# Access Compliance Report

## Public Rights-of-Way (Curb Ramps)

Intersection ID: 25094	Main Street: GRIMMERSBOROUGH_LN	Cross Street: PROVIDENCE MANOR_RD	Location: SW
ADA ID: EE4242A821A1	Ramp Type: Perp	Initial Pass/Fail: Fail	Overall Compliance: No
		Severity Score: 50

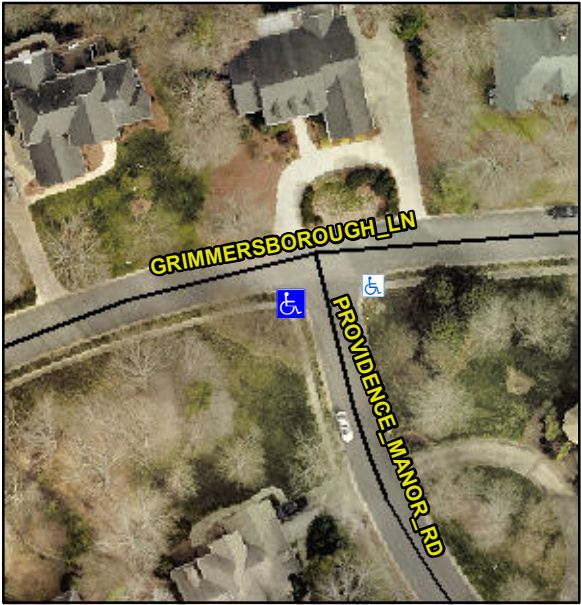
Codes/Mitigation Info/Possible Solution			Field Measurements/Component Compliance		
	Possible Solutions:		<b>Compliance</b>	<b>Description</b>	<b>Data</b>
	<b>Remove &amp; Replace Entire Ramp.</b>		<b>No</b>	Ramp Length (in)	<b>41.0</b>
			<b>Yes</b>	Ramp Width (in)	<b>48.0</b>
			<b>N/A</b>	Flare Type LT	<b>N/A</b>
			<b>N/A</b>	Flare Slope LT (%)	<b>N/A</b>
			<b>N/A</b>	Flare Traversable LT?	<b>N/A</b>
			<b>N/A</b>	Landing Length (in)	<b>N/A</b>
			<b>N/A</b>	Landing Width (in)	<b>N/A</b>
			<b>N/A</b>	Landing Slope (%)	<b>N/A</b>
			<b>N/A</b>	Landing X Slope (%)	<b>N/A</b>
<p>Surveyor Notes:</p> <p><b>N/A</b></p> <p>PROW/ADA:</p> <p><b>Not Found, R304.2.2, R304.5.3</b></p>			<b>N/A</b>	Flare Type RT	<b>N/A</b>
			<b>N/A</b>	Flare Slope RT (%)	<b>N/A</b>
			<b>N/A</b>	Flare Traversable RT?	<b>N/A</b>
			<b>N/A</b>	DWS Provided?	<b>N/A</b>
			<b>N/A</b>	DWS Contrast?	<b>N/A</b>
			<b>N/A</b>	DWS Length (in)	<b>N/A</b>

<b>N/A</b>	DWS Full Width?	<b>N/A</b>
			<b>N/A</b>	DWS Offset (in)	<b>N/A</b>
			<b>N/A</b>	Gutter Ponding?	<b>N/A</b>
			<b>N/A</b>	Gutter Lip Ht (in)	<b>N/A</b>
			<b>No</b>	Painted X Walk1?	<b>N/A</b>
				X Walk 1 Direction	<b>To E</b>
			<b>N/A</b>	X Walk 1 Width (in)	<b>N/A</b>
			<b>6.6</b>	X Walk 1 Slope (%)	<b>N/A</b>
			<b>4.4</b>	X Walk 1 X Slope (%)	<b>N/A</b>
			<b>N/A</b>	Ramp inside XWalk1?	<b>N/A</b>
			<b>N/A</b>	Road Slope (%)	<b>N/A</b>
			<b>N/A</b>	Road X Slope (%)	<b>N/A</b>
			<b>N/A</b>	Any Obstructions?	<b>N/A</b>
				Obstruction Type	
Total Cost: \$ 1850.00			<b>N/A</b>	Storm Grate/Utility Hazard?	<b>N/A</b>
			<b>N/A</b>	Storm Grate/Utility Type	<b>N/A</b>
			<b>Yes</b>	Surface Condition? (G/P)	<b>Good</b>
